Hume Highway Upgrade
Holbrook bypass
Environmental Assessment
Submissions Report
January 2010

Submissions Report

January 2010

NSW Roads and Traffic Authority

Figure 2-1 Noise catchment areas

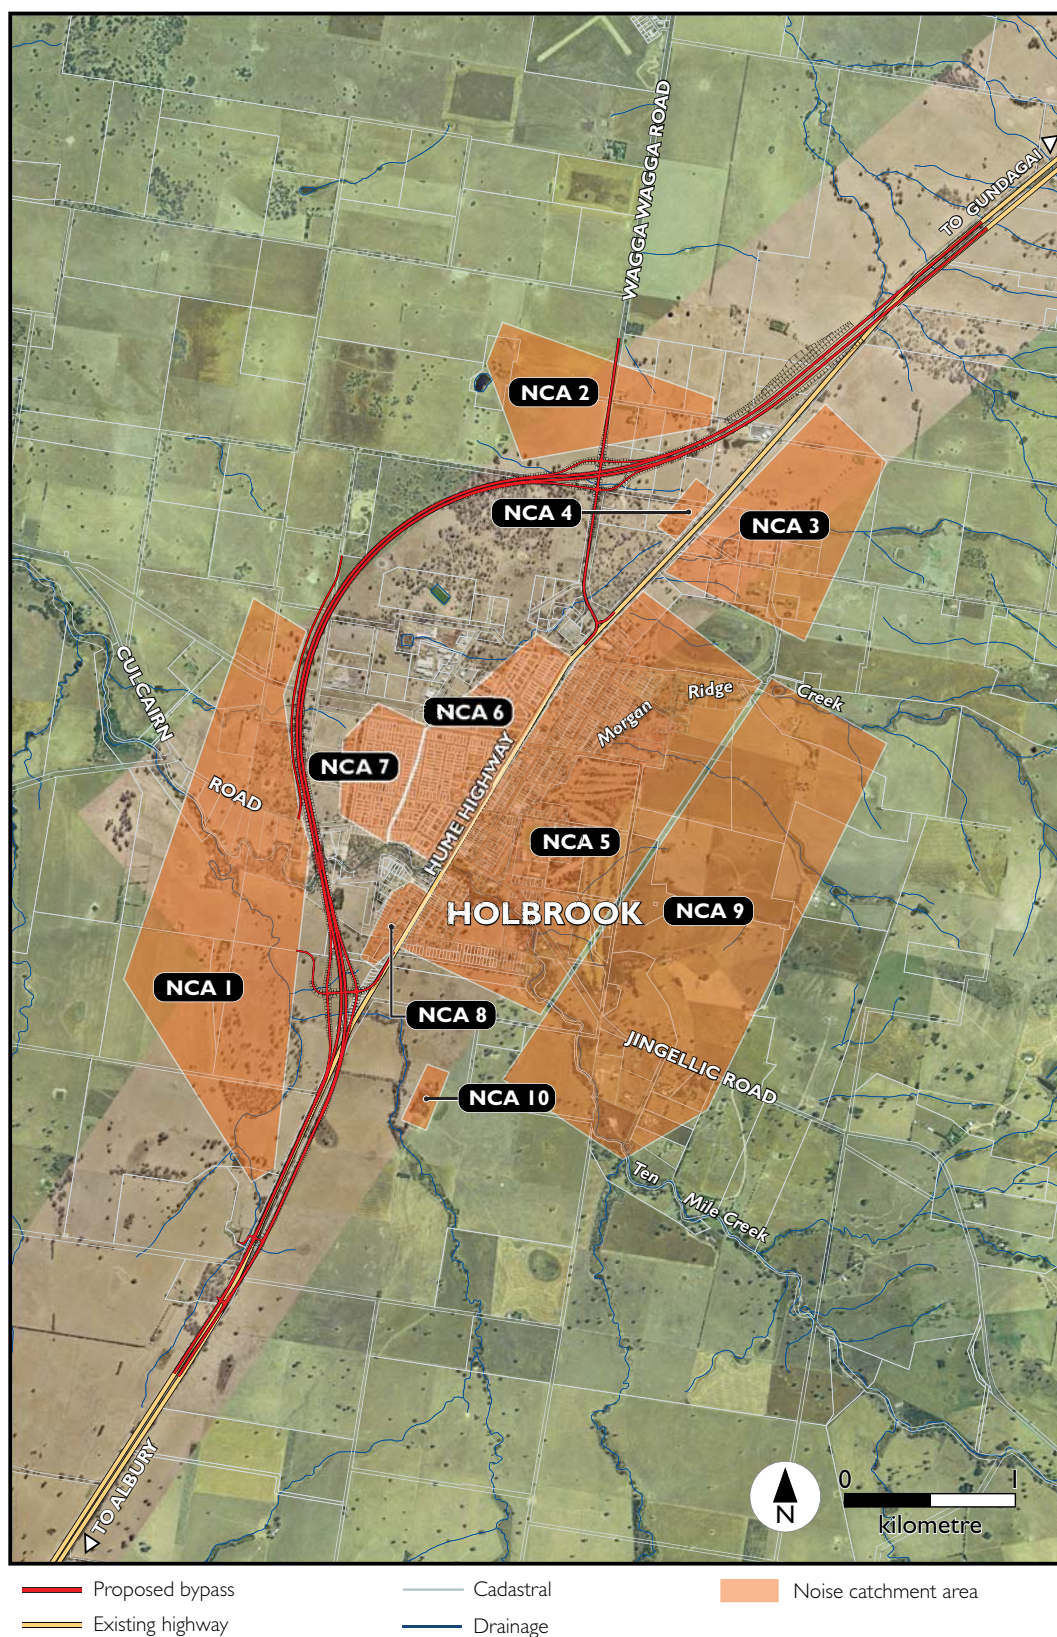
- The noise predictions in Table D1, Appendix D of Technical Paper 3 (Noise and Vibration) in the environmental assessment appear to be incorrect. The reported “future existing level 2012” for the western façade is the same as the eastern façade which cannot be correct due to shielding by the building.

A supplementary noise study (Wilkinson Murray 2010) has been prepared to address these issues and is included as Appendix A. Operational noise impacts have been reassessed with consideration of the revised future existing noise levels and a revised night-time traffic diversion scenario which assesses a 90 per cent diversion scenario for both light and heavy vehicles to the bypass (refer to Section 3.1.1). Revised predicted noise impacts require consideration of reasonable and feasible mitigation operational noise treatment at an additional 32 receivers from what was considered in the environmental assessment. Two receivers are isolated residences and may be considered for architectural treatment, and the others are part of a group where noise would be mitigated by at-road treatments near the southern interchange. There has been an overall reduction in the revised receivers exposed to acute levels under the 90 per cent diversion scenario.

The noise catchment areas are shown in Figure 2-1.

Figure 6-1 Mitigations for 90% Night Diversion Scenario

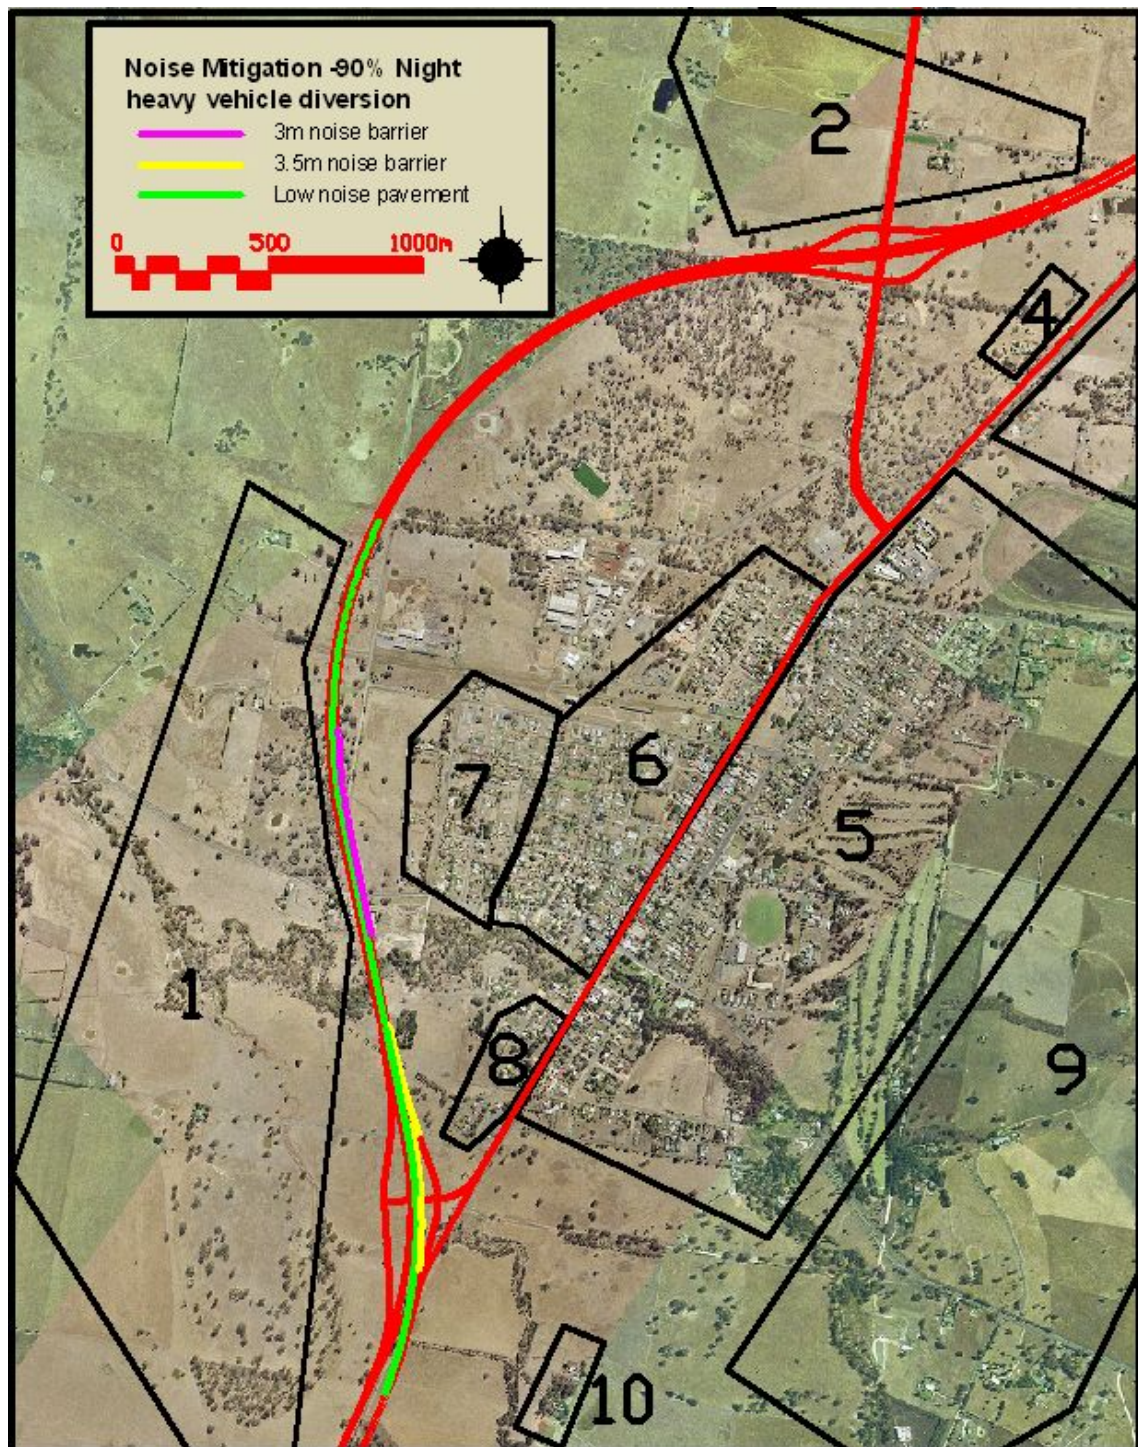
- The high diversion scenario used for noise modelling is based on daytime origin-destination survey. This is not considered a valid process as the travelling purpose and destination is fundamentally different at night. This requires a response from the proponent and should not be left to detailed design.

Under the “90% Night Diversion” scenario, the bypass is predicted to generate exceedances at a considerable number of receivers in NCA 7 and NCA 8.

The indicative at-road operational noise mitigation proposed in the environmental assessment for NCAs 7 & 8 would be revised to include low noise pavement, barriers and the use of Asphaltic Concrete, or similar on the Culcairn Road overpass. The revised mitigation measures discussed in the supplementary noise assessment (Appendix A) includes the extension of the noise barriers near NCA 7 & 8. Architectural treatment would be considered for the additional operational noise impacts at receivers 256 and 257 in NCA 4. It should be noted that operational noise mitigation measures would be subject to detailed design and would be developed in consultation with affected landowners. Refer to Section 3.1.3 and Section 3.1.4.

Whereas under the “High Diversion” scenario there was a choice of mitigation available - i.e. barriers, low noise pavement or a combination of both - with the 90% Night Diversion scenario only a combination of low noise pavement and barriers will achieve the required performance. For comparison, if low-noise pavement were adopted as a mitigation strategy for the “High Diversion” scenario, then under the “90% Night Diversion” scenario the following **additional** barriers would be required:

The noise mitigation is shown in Figure 6-1. It would achieve compliance at all non-isolated receivers. The mitigation consists of:
